Catalpa and Malus trees on frontage of St Mary's Church

I refer to the enquiry you forwarded from Nick Bell (London Borough of Camden Tree Officer) regarding quantifying the amount of pruning required on these two trees to accommodate the proposed ground floor extension.

6. Catalpa estimated Pruning (Same branches as Photo 4)

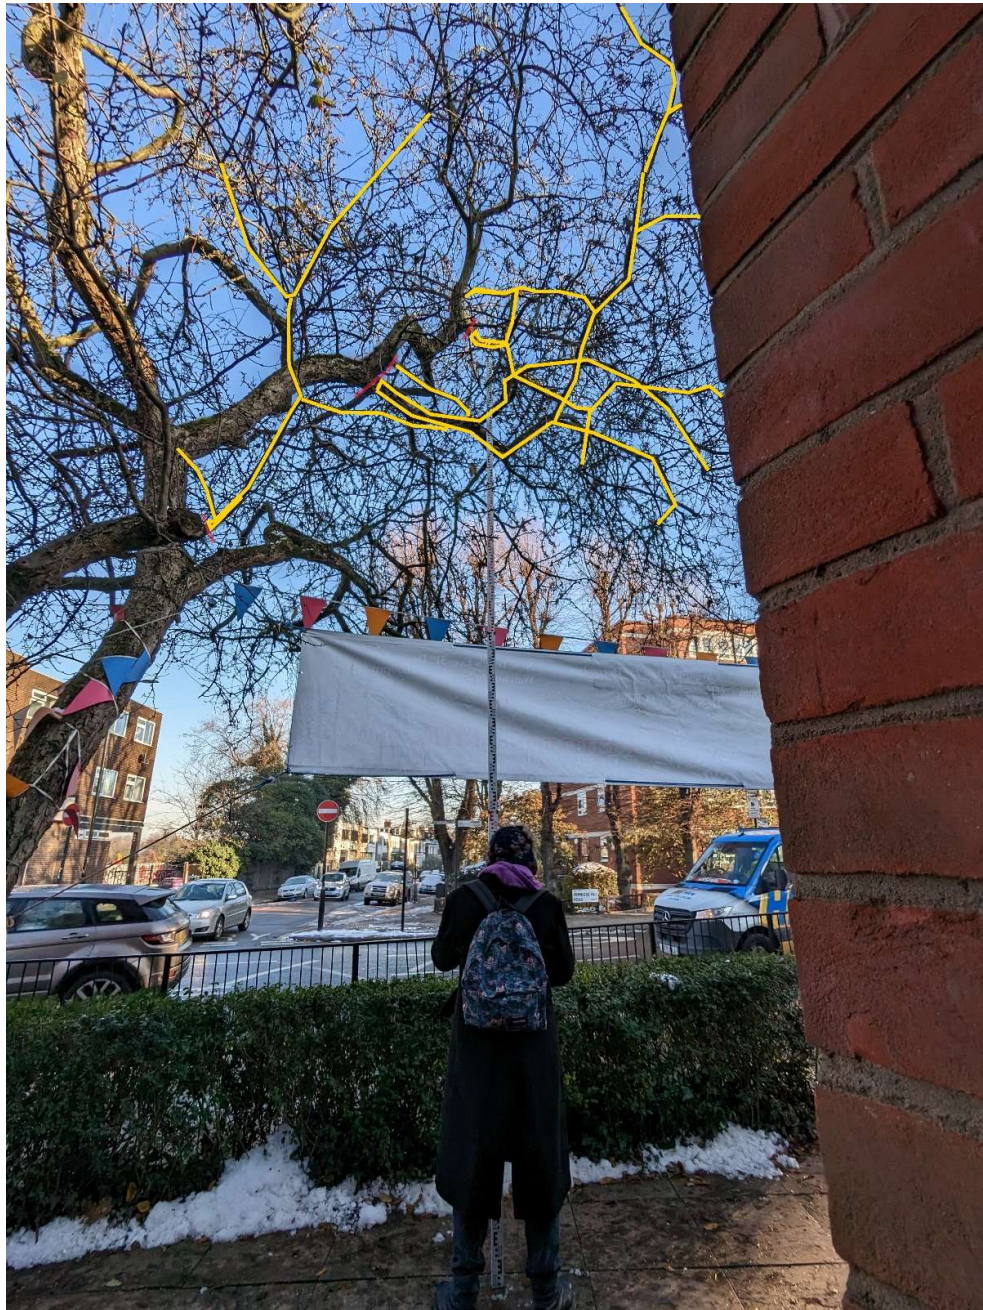
I am getting in touch in relation to the above planning application. I agree with your assessment in that the below-ground impact on trees to be retained will likely be of an acceptable level provided suitable foundations are used. Your report makes reference to pruning the Catalpa (T5) and Apple (T6) but does not give a pruning specification:

Please reply with quantified pruning proposals for all affected trees and proposed post-pruning crown spreads inc. allowance for working room to allow me to fully assess the impact of the scheme. I note your reference to removing the Catalpa,

The crown is three dimensional so I have tried to indicate the estimated pruning points and the parts of the tree that will be removed in the following photographs. The pruning position of the branch is marked in red or shown with a red arrow when the pruning point is obscured by another branch. The main parts of the branch removed are highlighted in yellow. I think this is too complicated to describe in sentences with any degree of accuracy. Please note that I have not marked the smallest twigs only the main branches although the parts of the Malus affected are smaller than the Catalpa.
